RECALL CAMPAIGN 17V-067: REPLACE THE FLEXIBLE DISC ON THE REAR DRIVESHAFT

New information provided by this revision is preceded by this symbol .

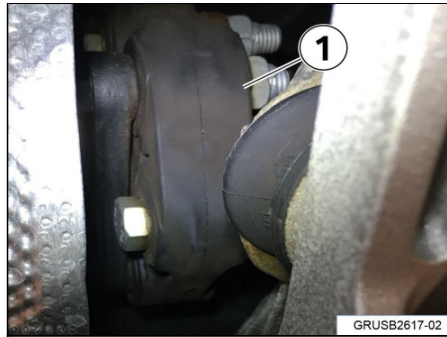
Materials selected for the front (transmission side) flexible disc may be subject to premature failure in this application.

Check the revision index number on the flexible disc and if necessary replace the flexible disc.

1. Check the revision index number on the installed flexible disc.

- A. Rotate the driveshaft until the revision index (1) and part numbers on the disc are visible.

Is the index number (the last two digits of the top part number) "01" or "02"?

YES- go to step 2.

NO (index number 03) – do not replace the flex disc and reinstall all parts removed for inspection.
